OUZINKIE OFFICE
 OUZINKIE NATIVE CORP.
 SPRUCE ISLAND, ALASKA

ELECTRICAL SHEET LIST	
NUM	SHEET TITLE
E0.1	LEGEND
E0.2	SPECS.
E0.3	SCHEDULES
E1.1	CRAWLSPACE ELECTRICAL PLAN
E2.1	LEVEL 1 LIGHTING PLAN
E2.2	LEVEL 2 LIGHTING PLAN
E3.1	LEVEL 1 POWER AND SIGNAL PLAN
E3.2	LEVEL 2 POWER AND SIGNAL PLAN
E4.1	ONE-LINE DIAGRAMS, DETAILS, AND SCHEDULES
E5.1	PANEL SCHEDULES
E5.2	PANEL SCHEDULES
TOTAL SHEETS: 11

* 27 NOVEMBER 2017 * ADDENDUM NO. 1 *

DR: KMM
CK: EDC
DT: 10/31/2017
JB: OUZINKIE
DWG: ONE-LINE DIAGRAMS, DETAILS, AND SCHEDULES

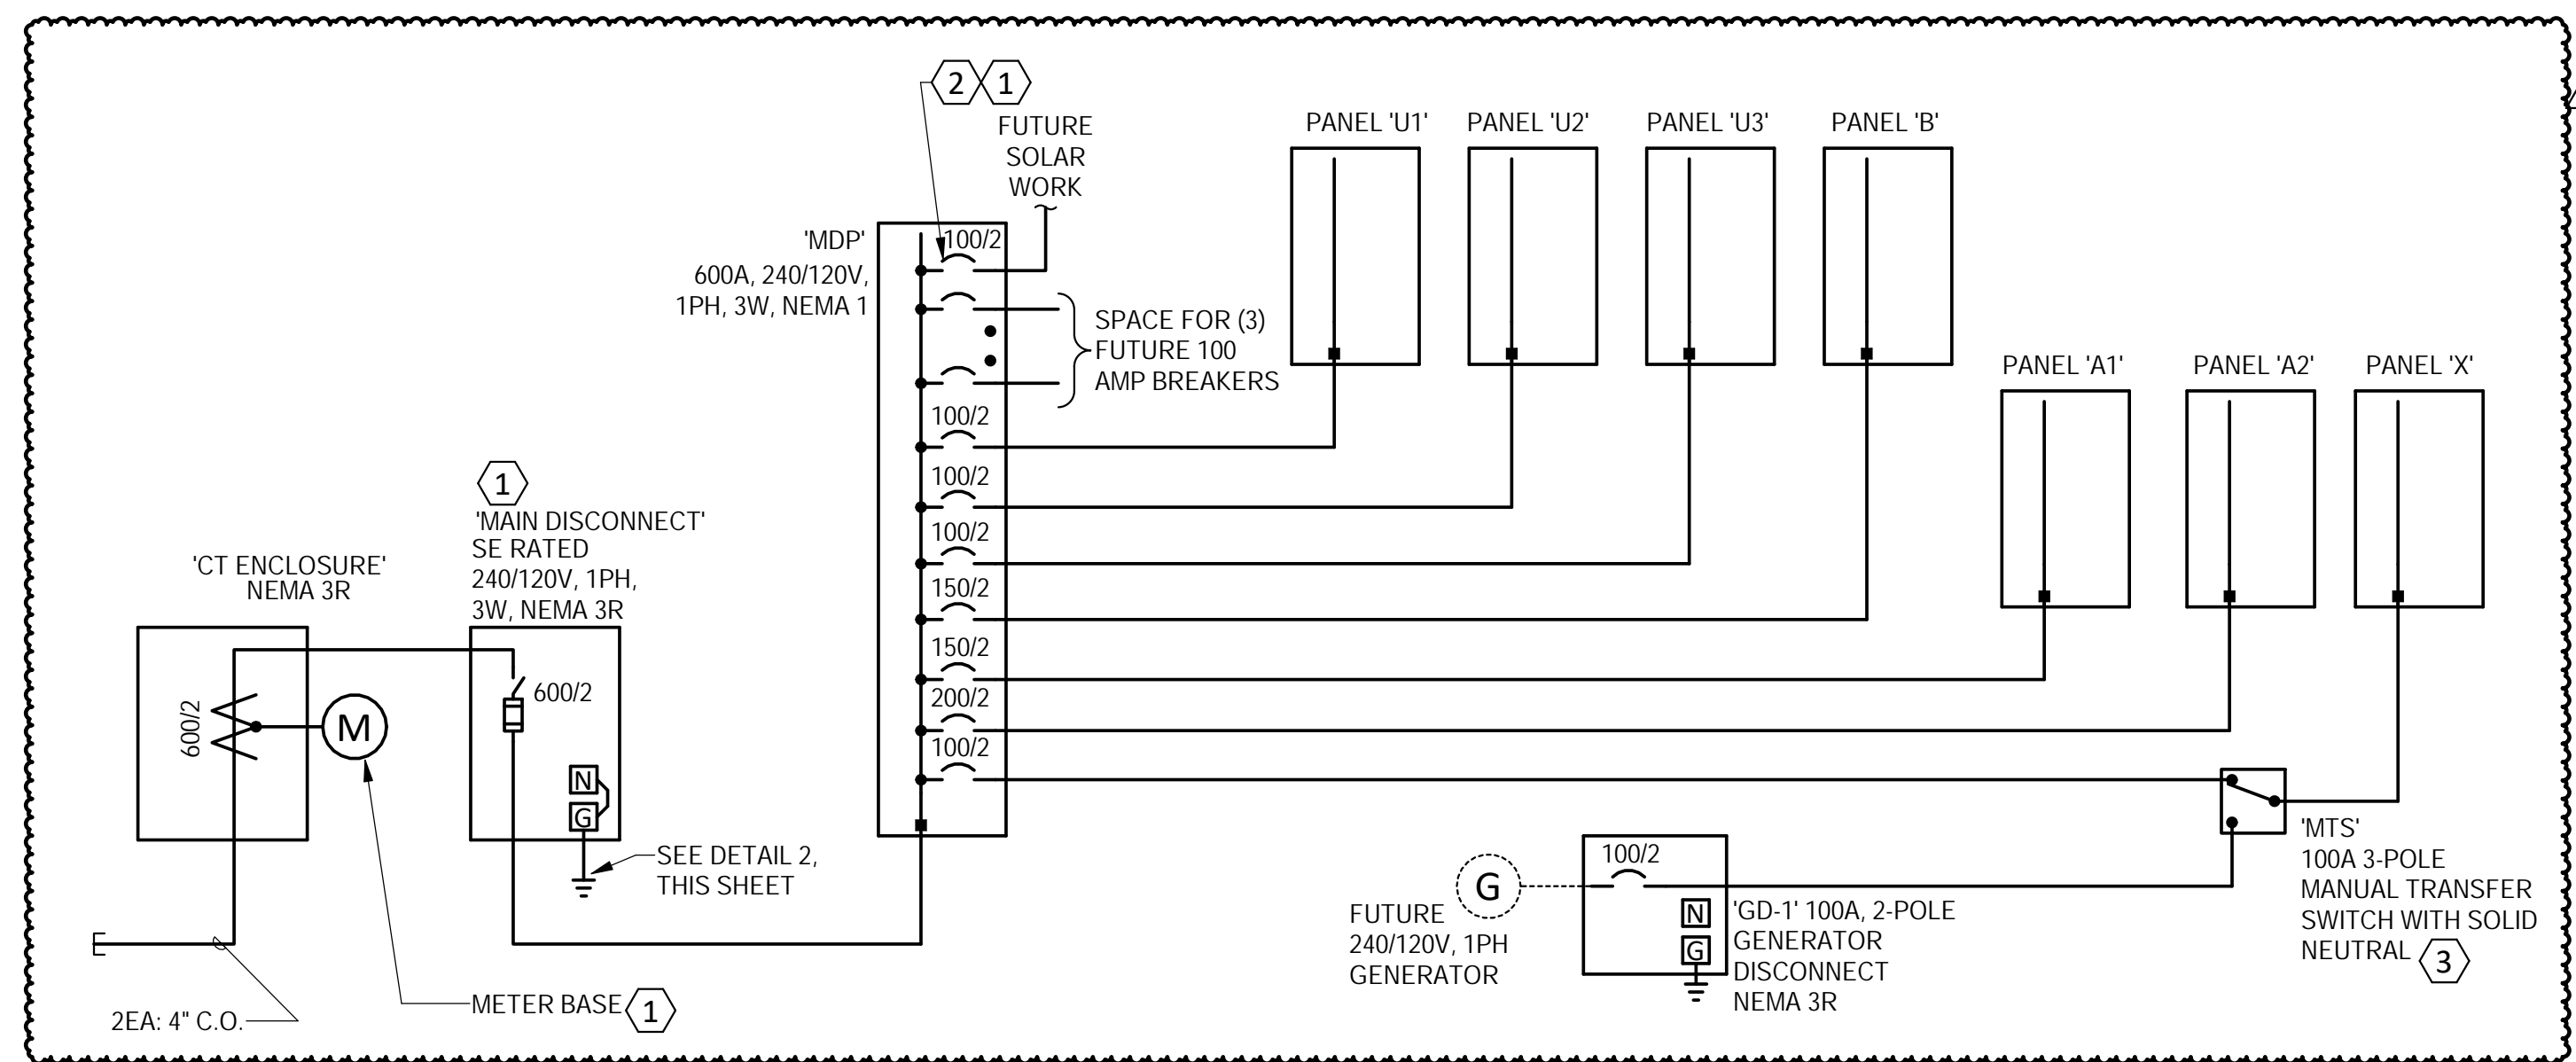
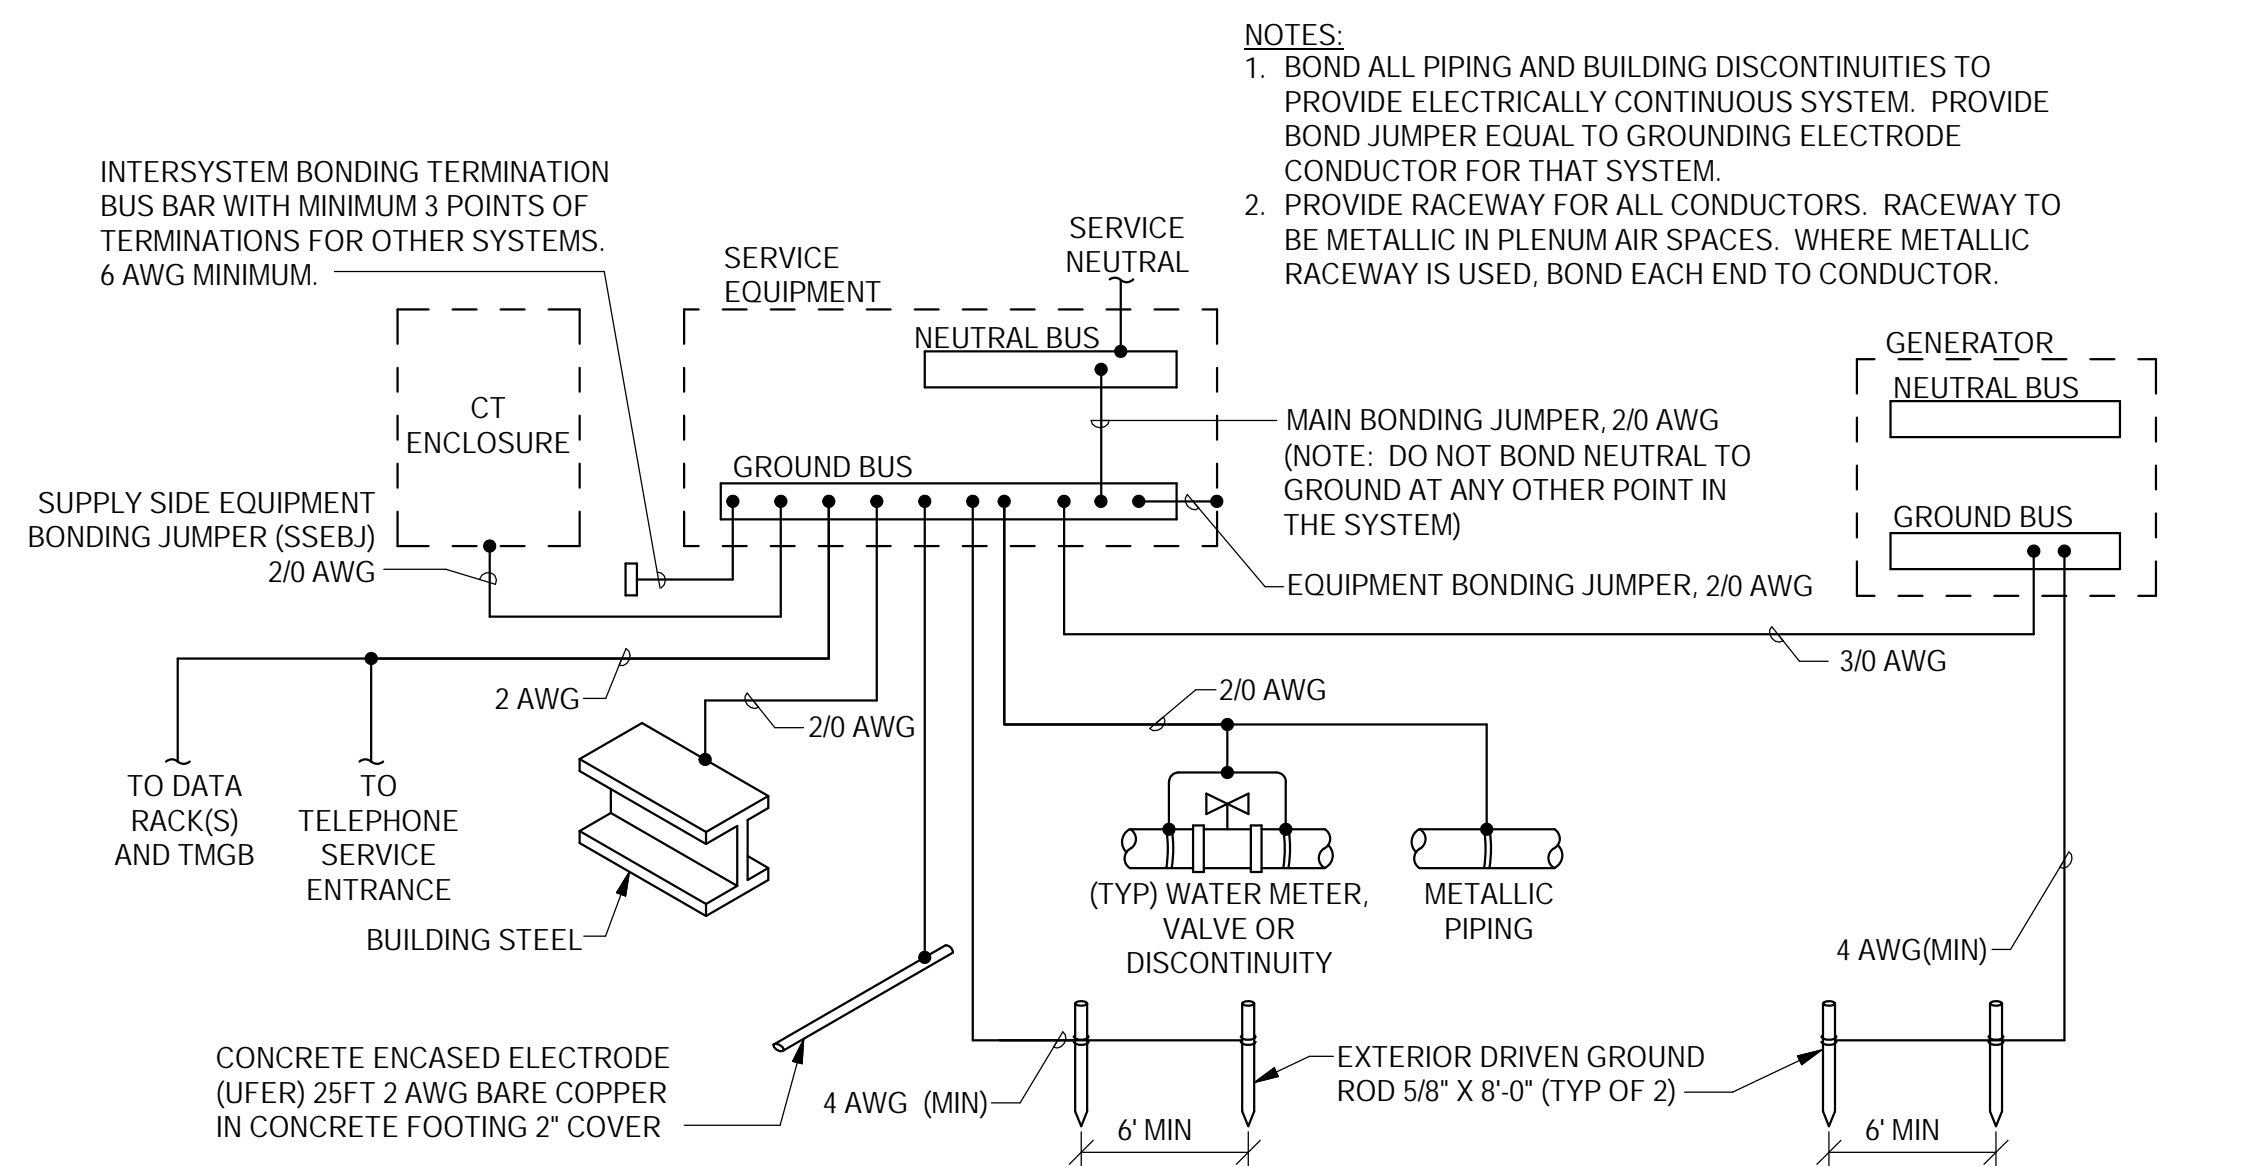
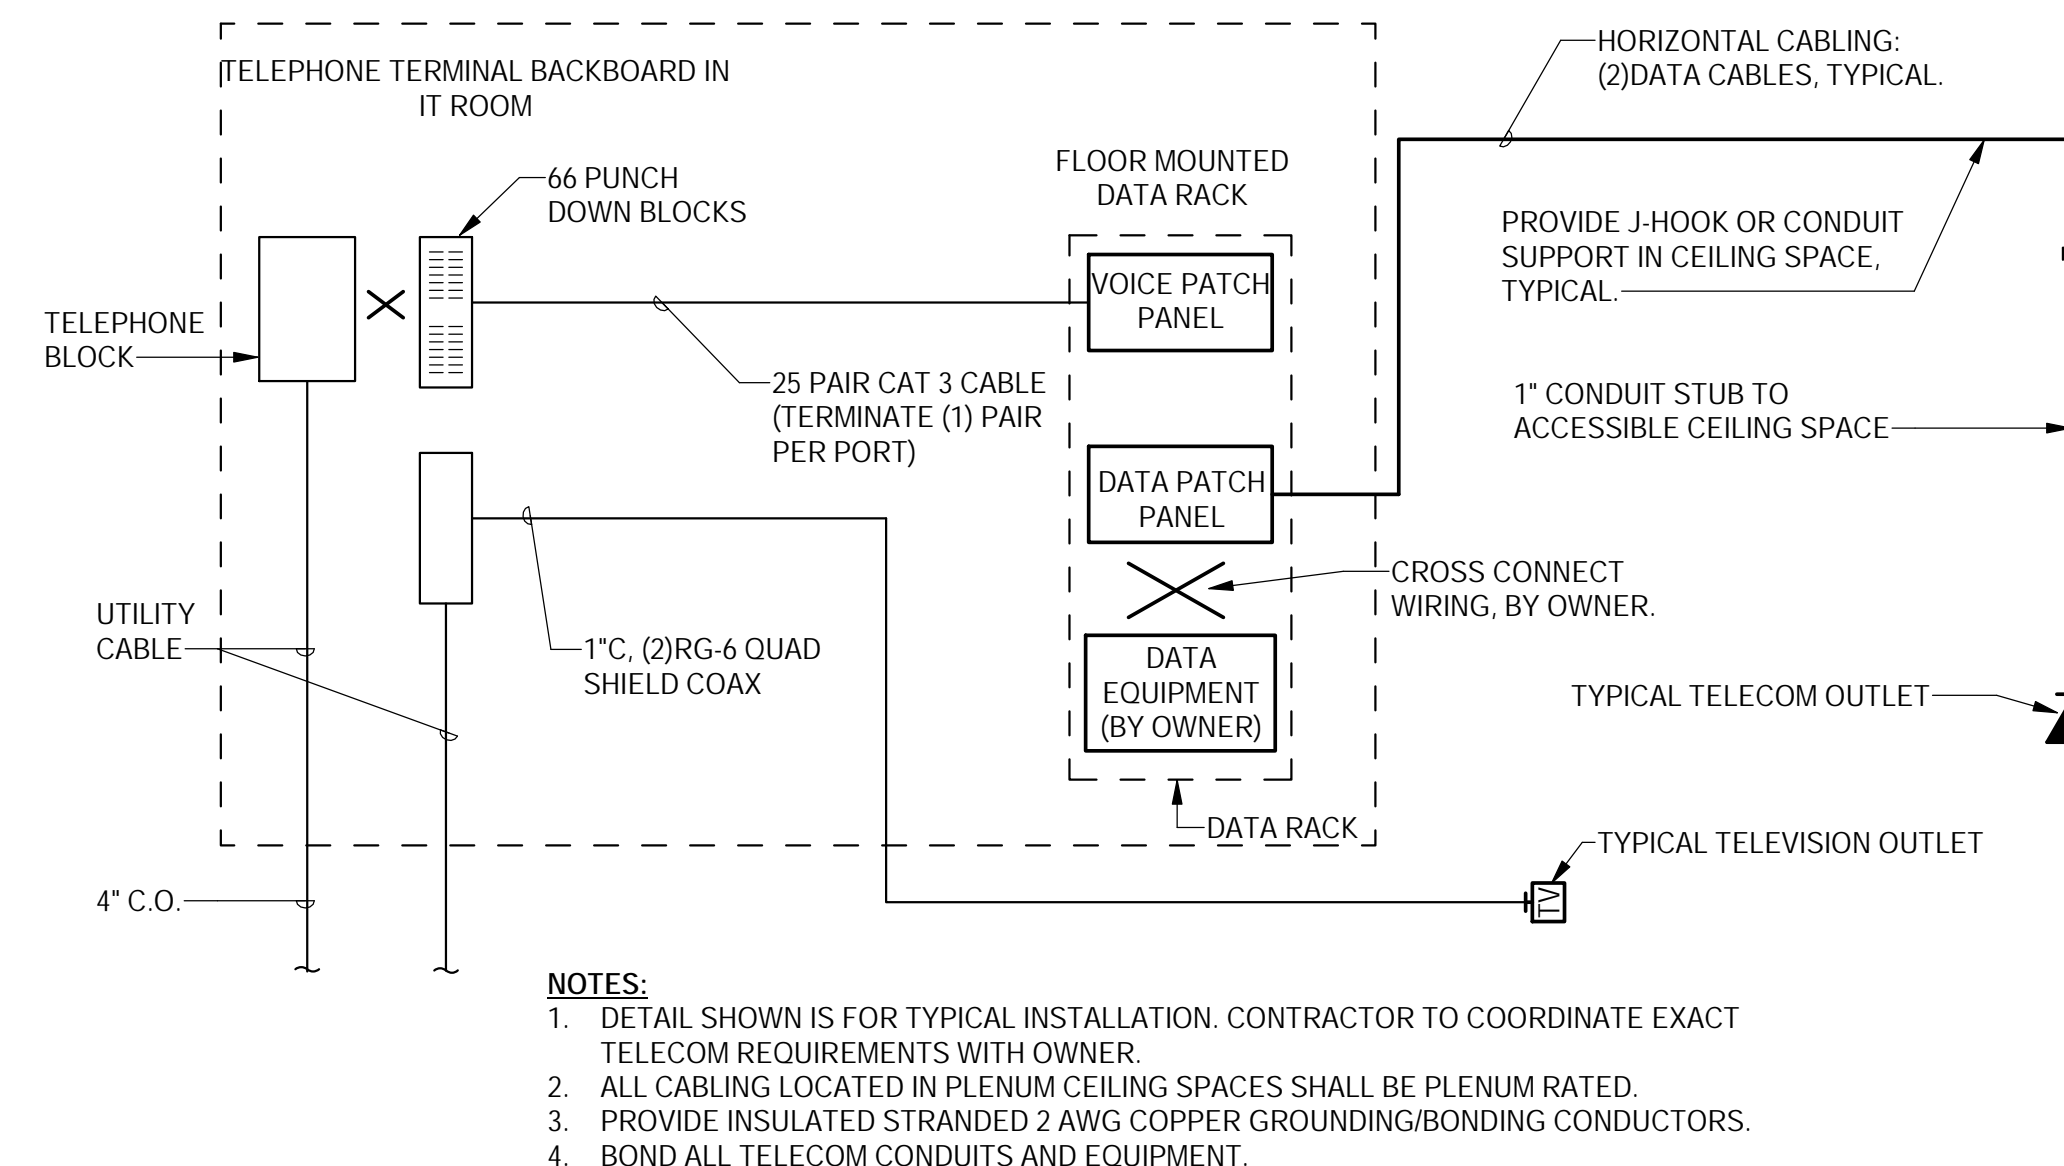
- EQUIPMENT TO BE BACK-FEED RATED FOR FUTURE SOLAR SYSTEM INSTALLATION.
- BREAKER TO BE SHUNT TRIPPED FOR FUTURE SOLAR SYSTEM INSTALLATION. LOCATE BREAKER AT OPPOSITE END OF PANEL FROM INPUT FEEDER LUGS.
- DO NOT SWITCH NEUTRAL. SPARE POLE PROVIDED TO ALLOW RECONFIGURATION TO SEPARATELY DERIVED DEPENDING ON GENERATOR INSTALLED IN FUTURE PHASE.

NUM	DATE	DESCRIPTION
1	11/27/2017	REVISED FOR FUTURE SOLAR WORK
